Product Change Notice

Improved tube design.

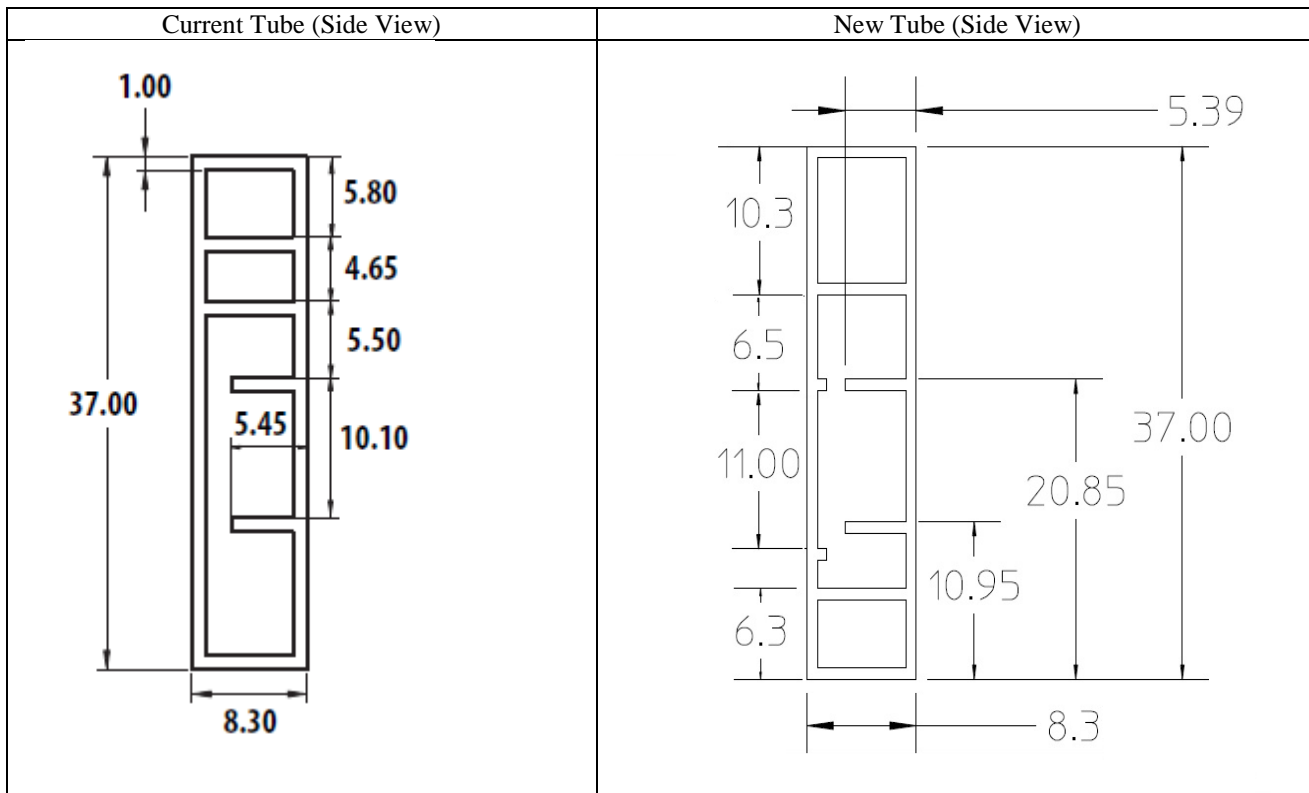
Below is the design comparison of the current and new tube.

Improvement on the dimension of the tube, which provides better fit for the unit inside the tube. This is to avoid units stuck inside the tube.

The change is limited to the tube design and dimension only. There is no change in the material of the tube. There is no change in the fit, form and function of the device.
